ADDENDUM E-1

January 7, 2025

Ramsey County Courthouse
Electrical System Upgrade
Devils Lake, ND

Project #24062

MDP ELEVATION
NO SCALE

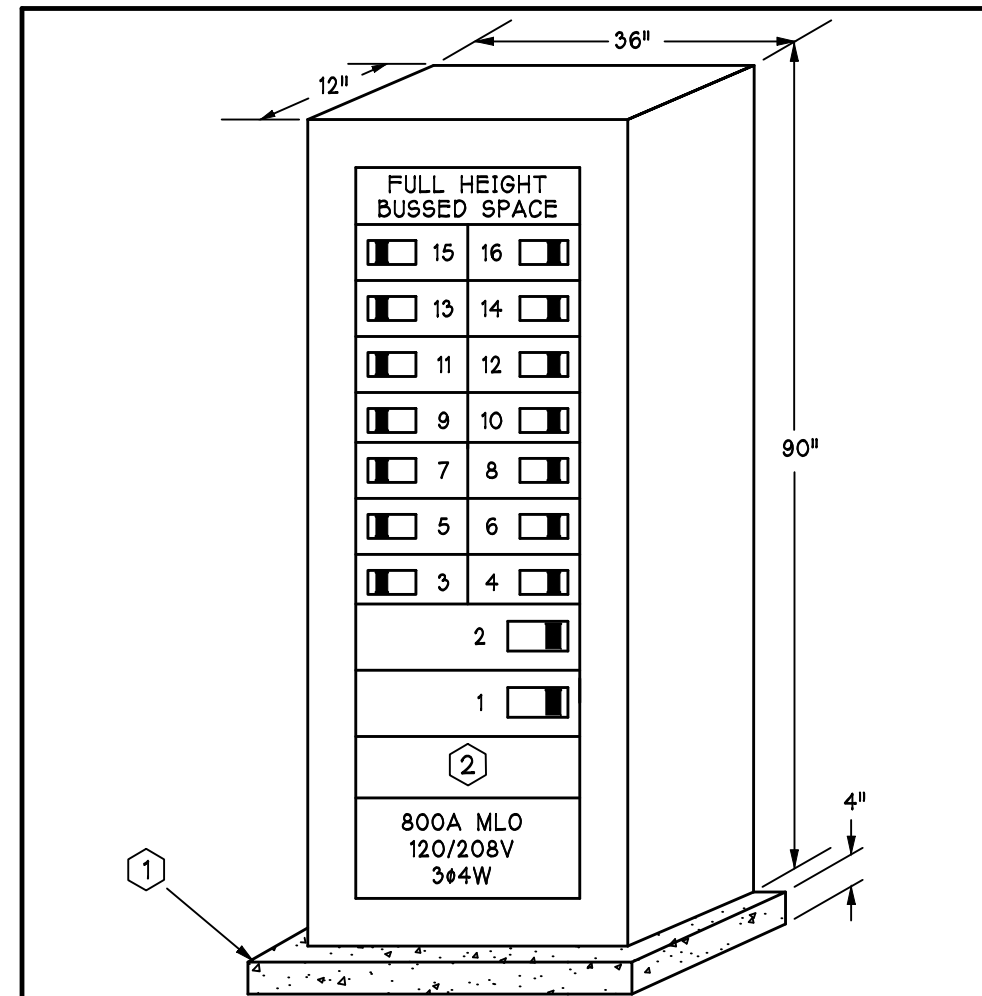
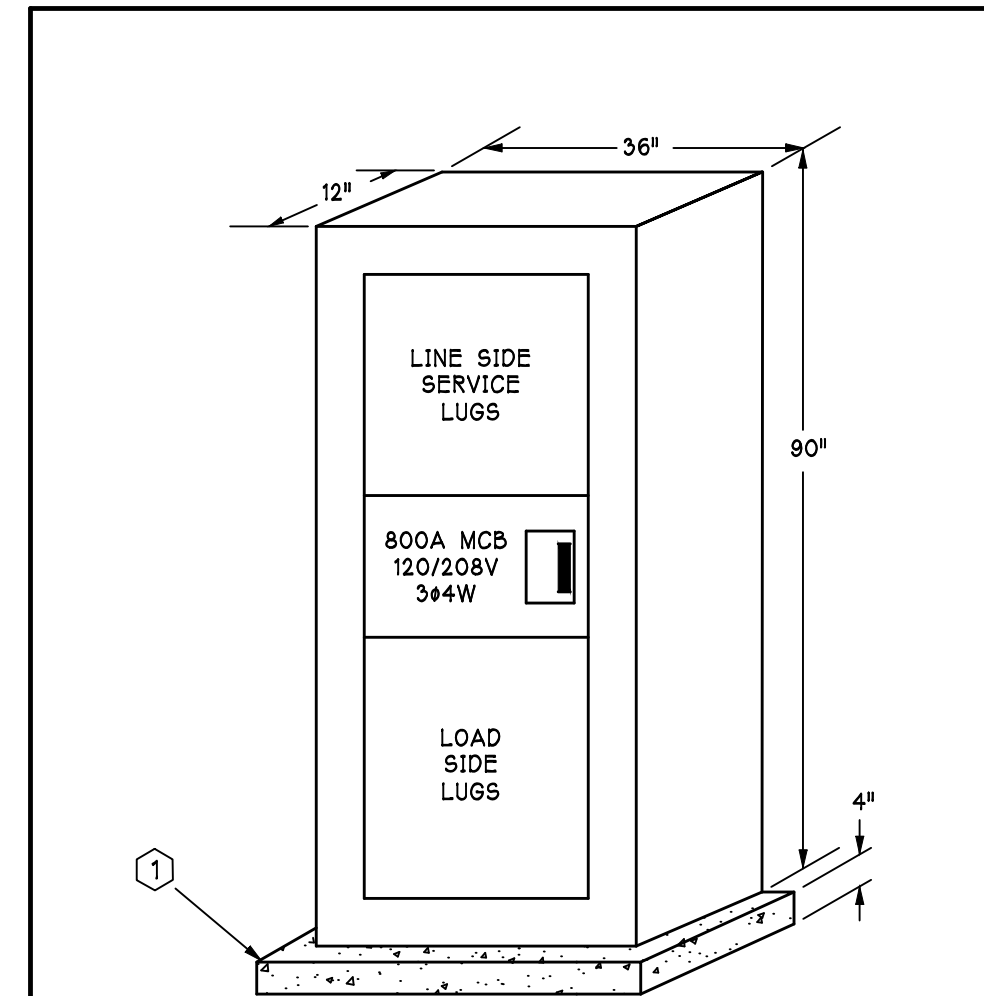
DRAWING ITEM #2. Detail 3/E2.1

- A. Change Circuit Breaker #1 to 700/3 in lieu of 600/3.
- B. Add Circuit Breaker #15 – 100/3 spare.
- C. Add Circuit Breaker #16 – 70/3 Chilled Water Pumps 1&2.

UPGRADED RISER

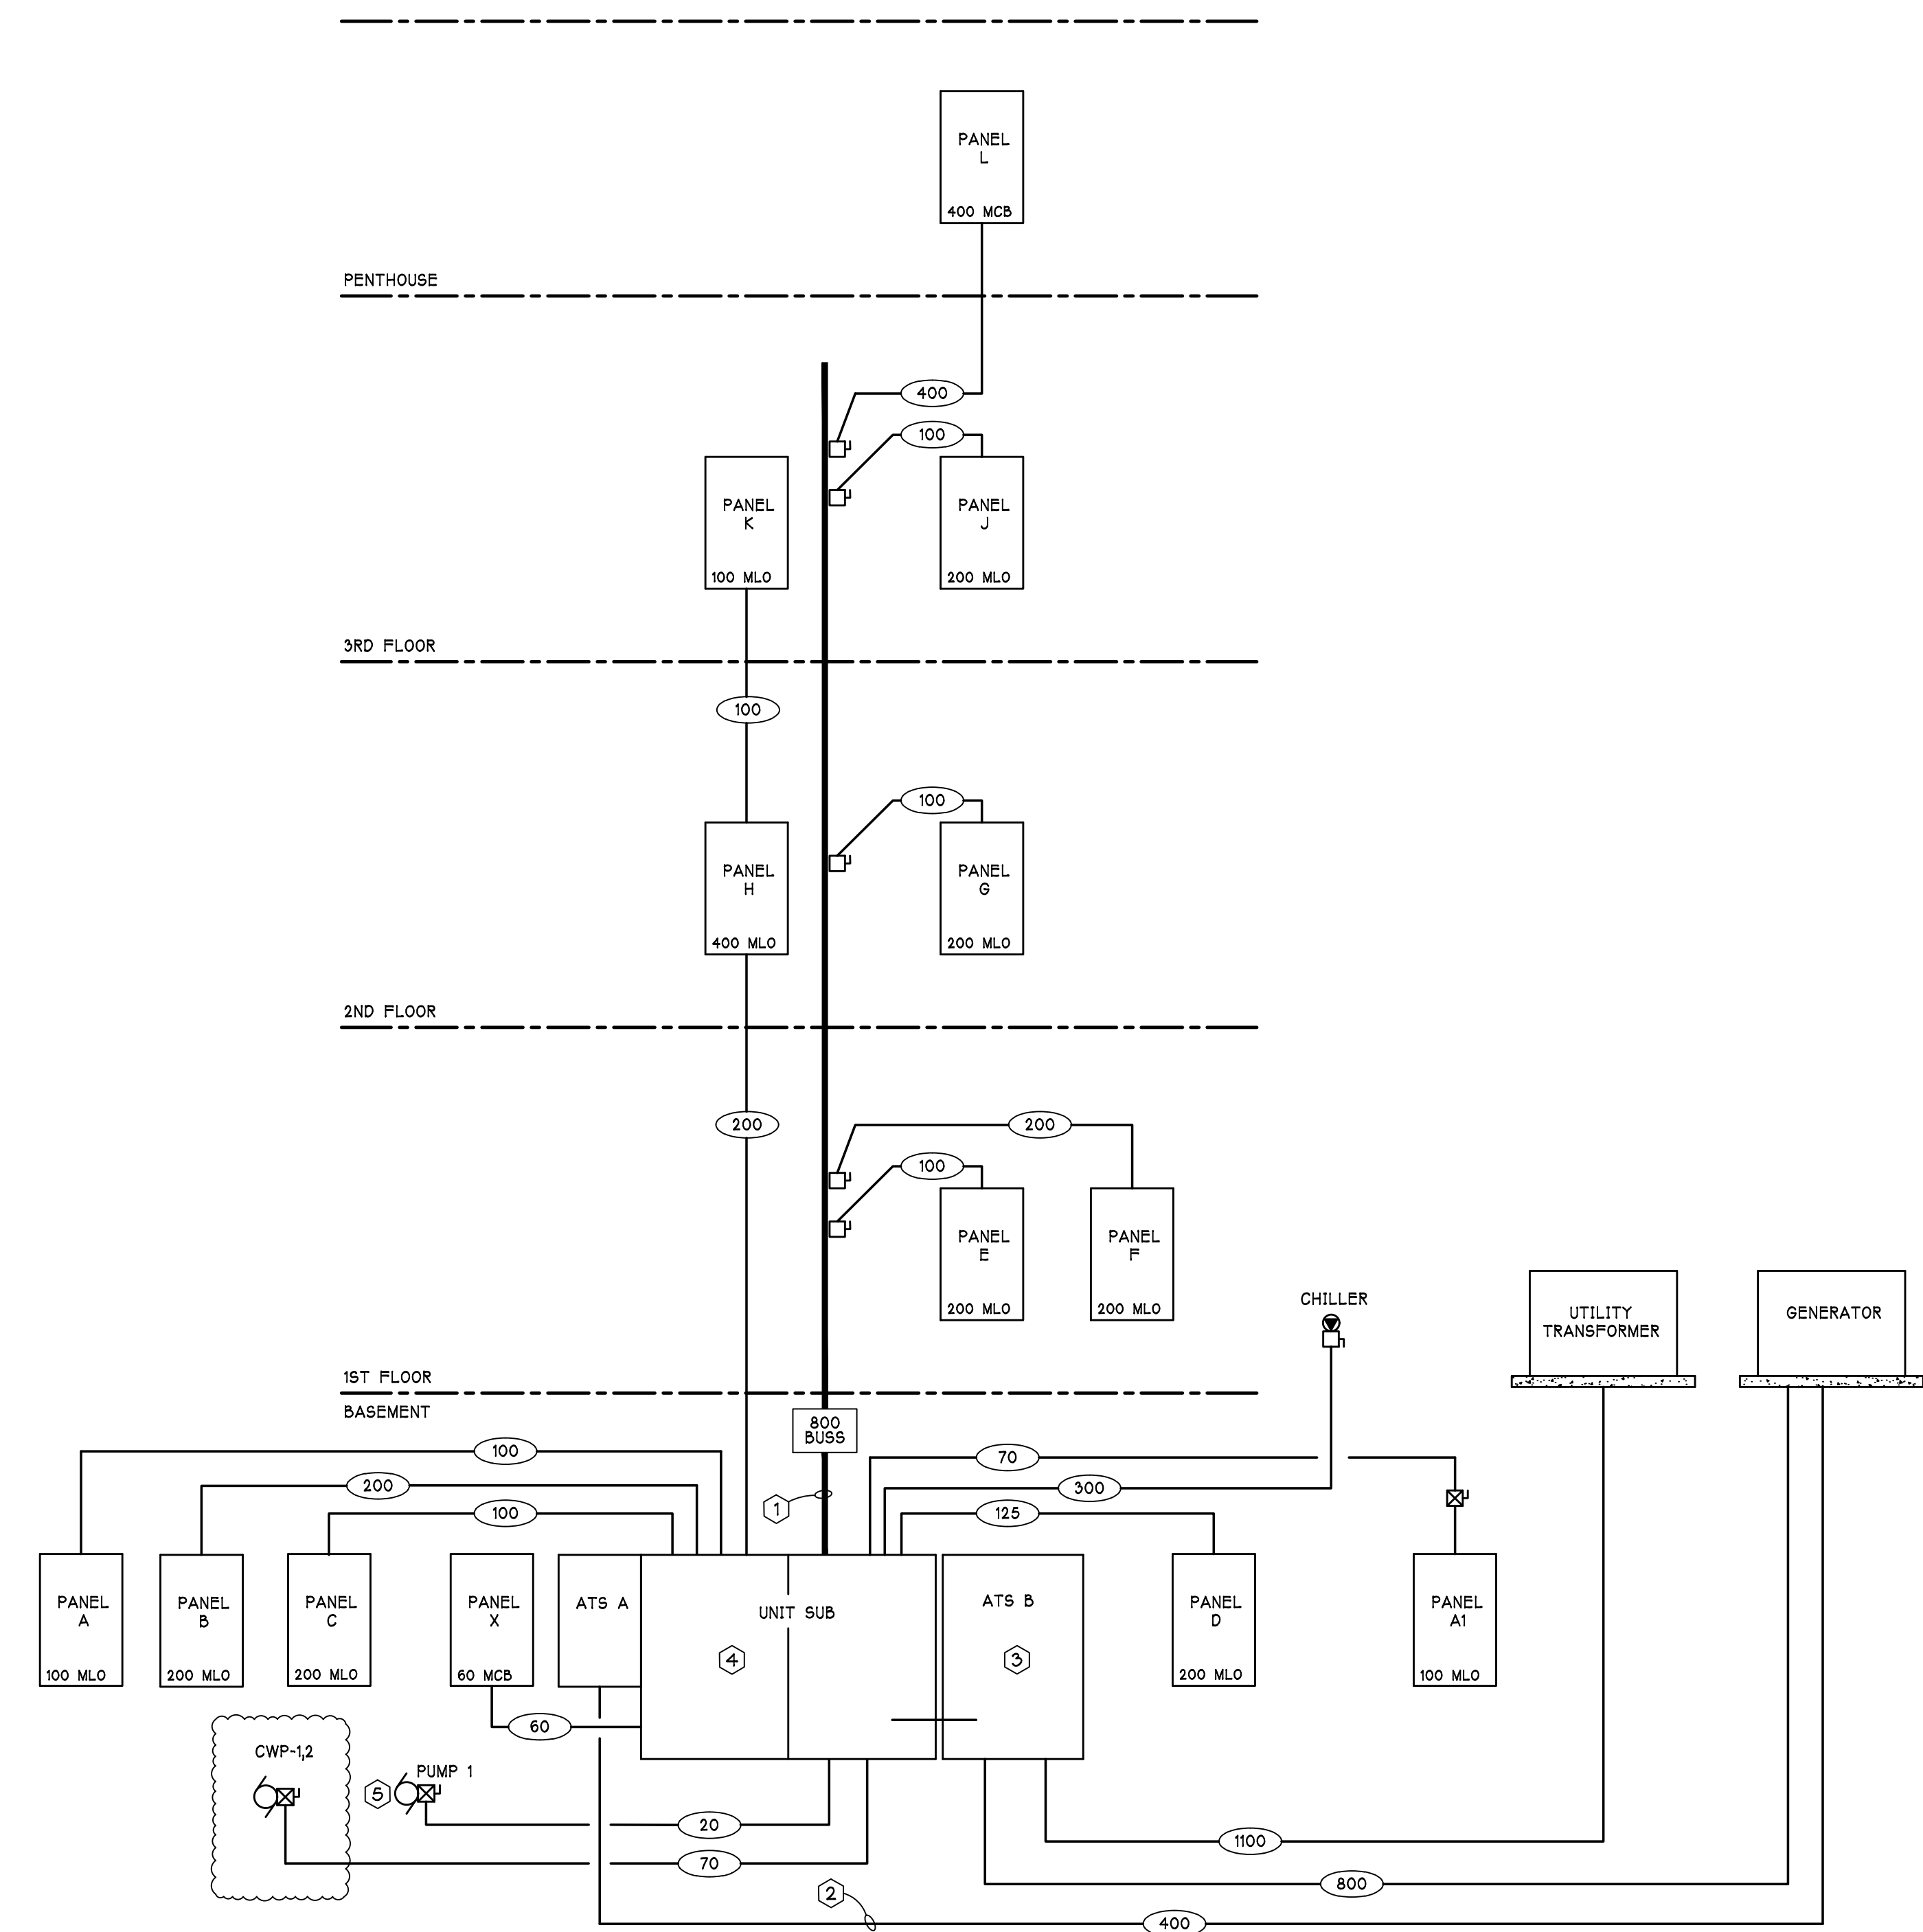
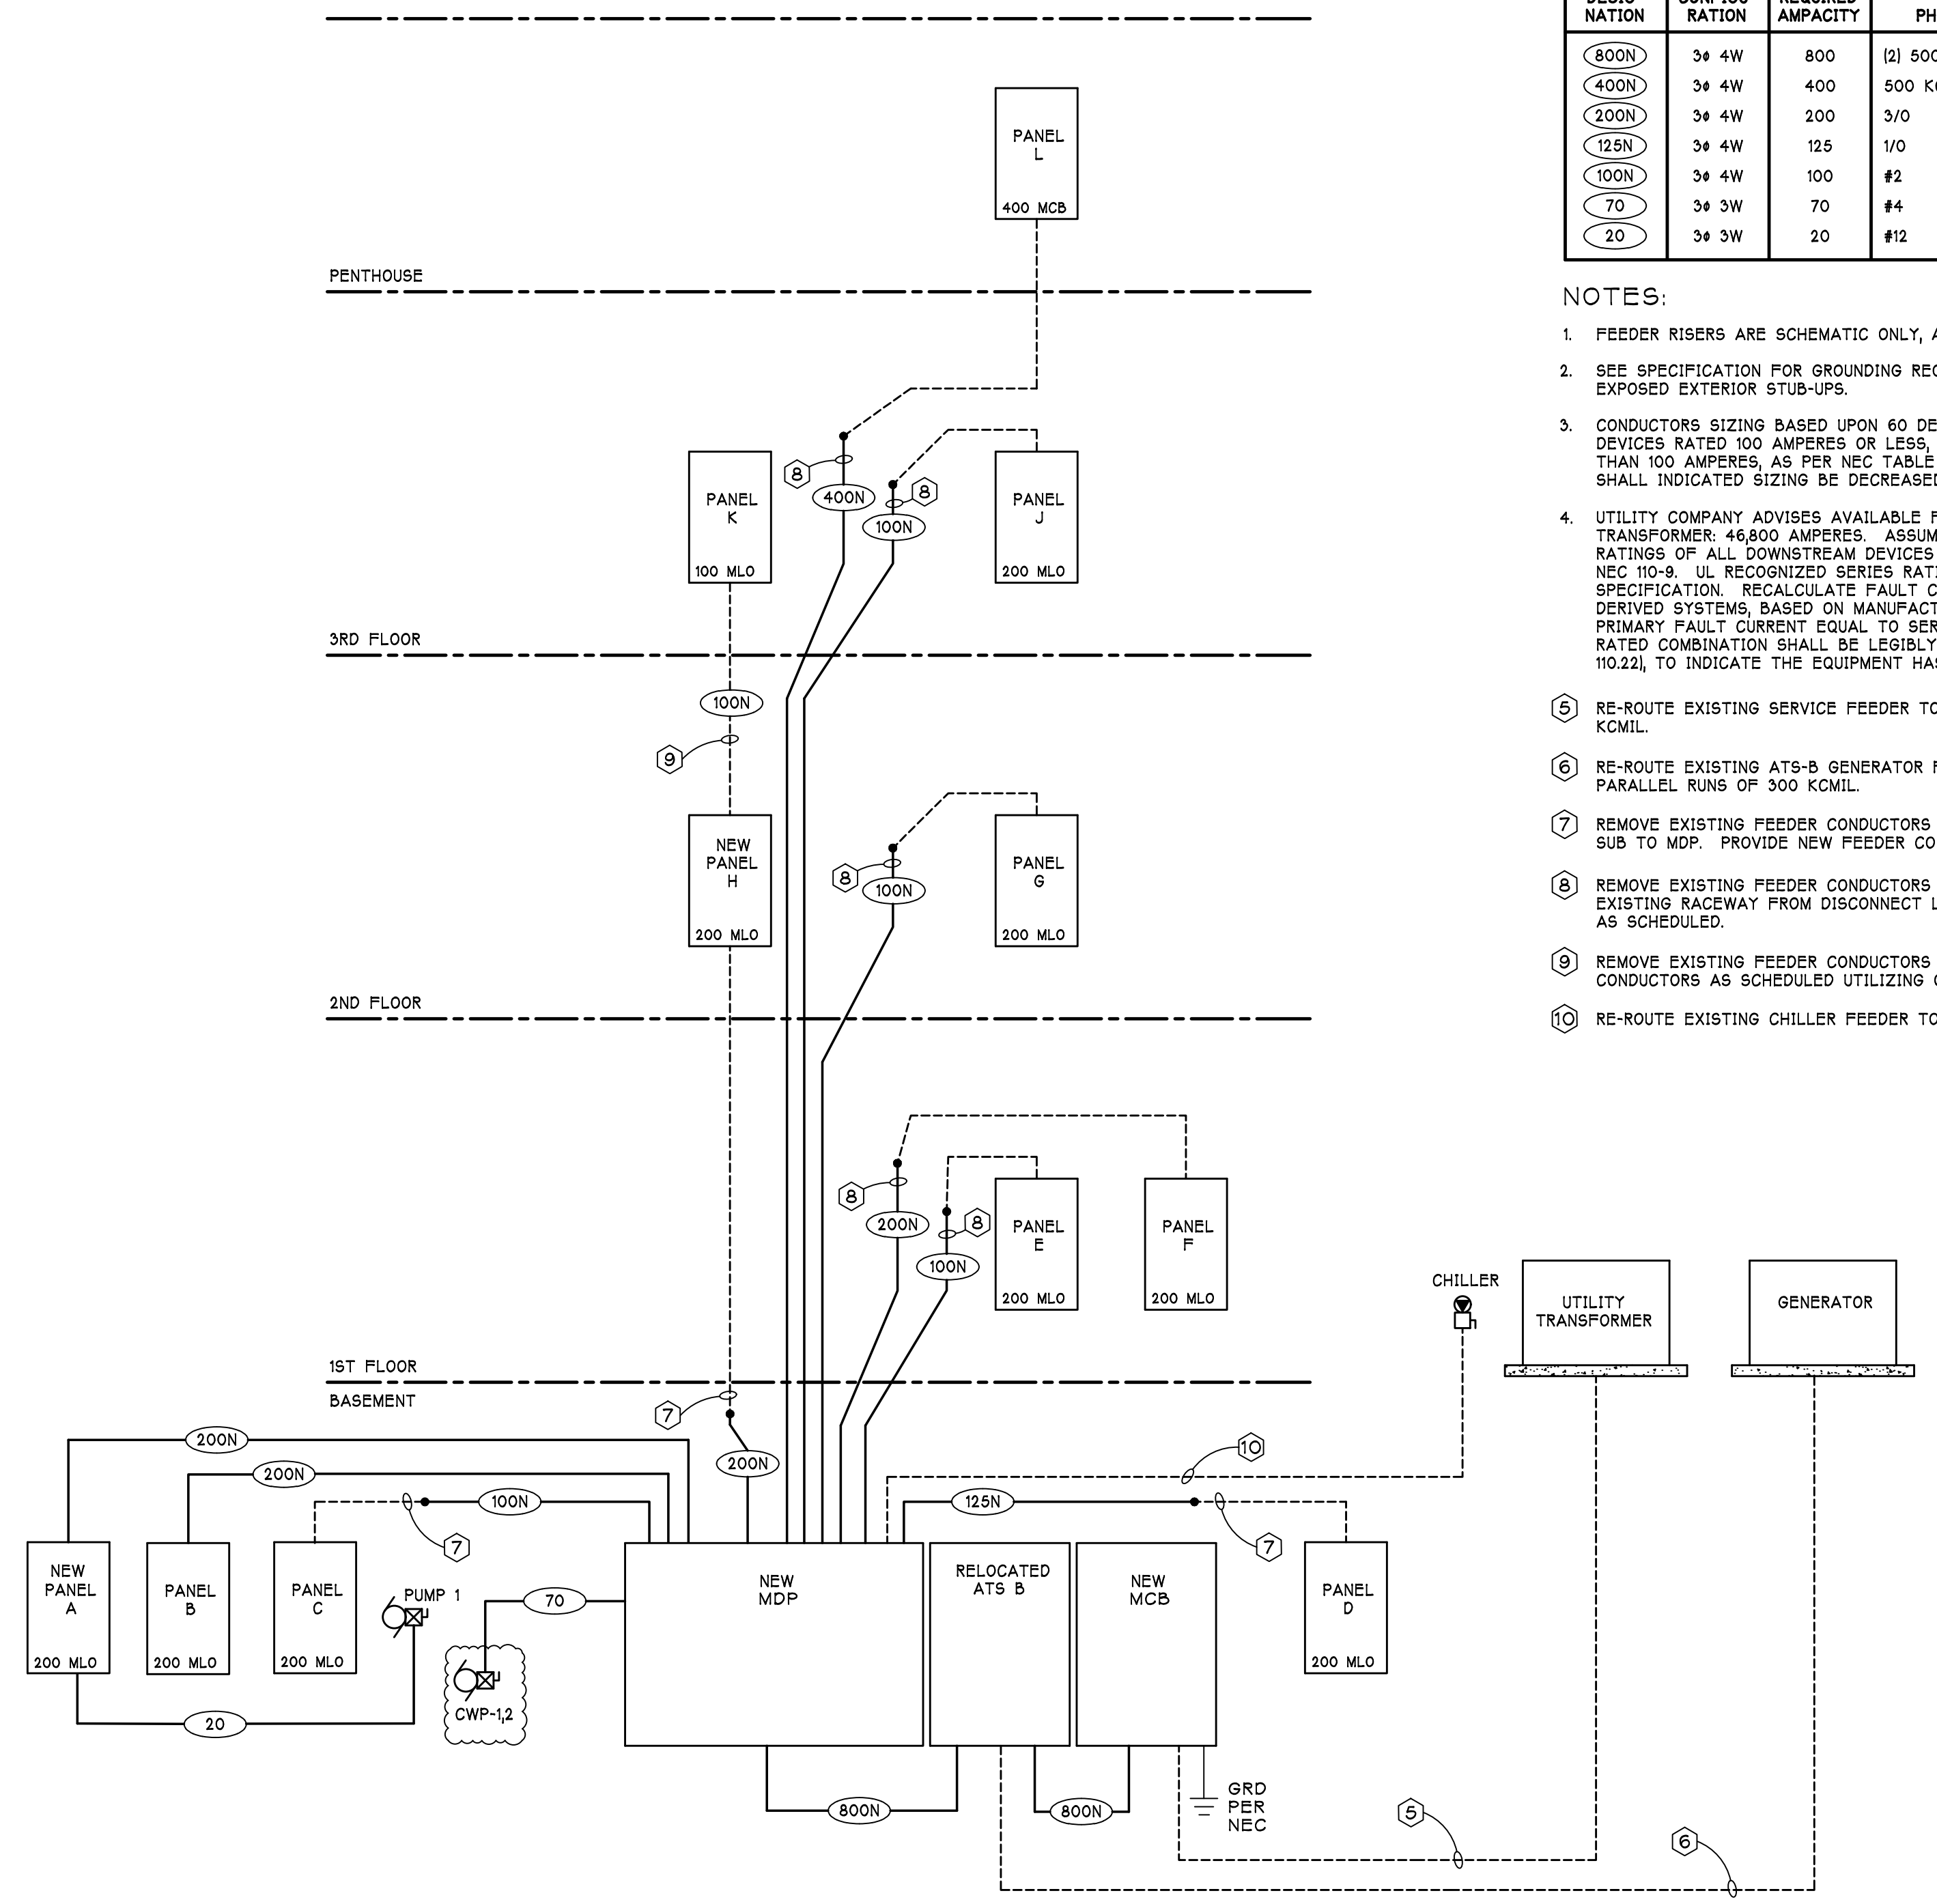
DRAWING ITEM #1. Detail 1/E2.1 and 1/E2.2

- A. Existing feeder to Chilled Water Pumps 1&2 from Unit Sub shall be refed from new MDP. Pumps are located in the Maintenance Room.
